Document No. : DSHKB-2607-B01

Notice of Changes of LED Chips for LCD Module

Products Affected: TCG084VGLACANN-AN00, TCG121WXLBABNN-AN20,
TCG121XGLPAPNN-AN20-TA

1) LED Chips

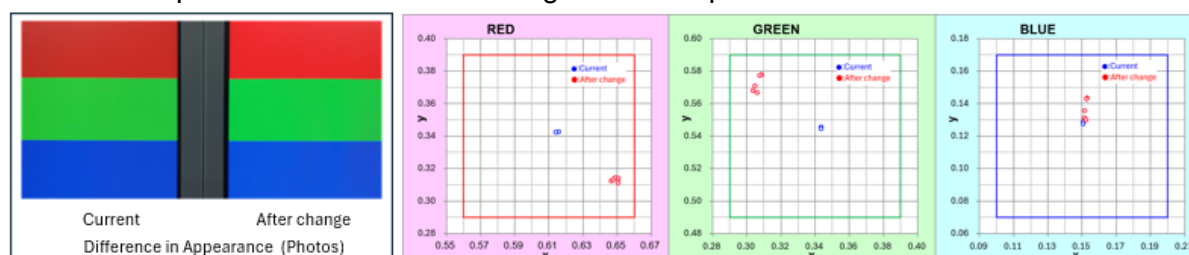
Current	After change
LED Manufacturer	Company L	(To be updated)
LED Part Number	O	P
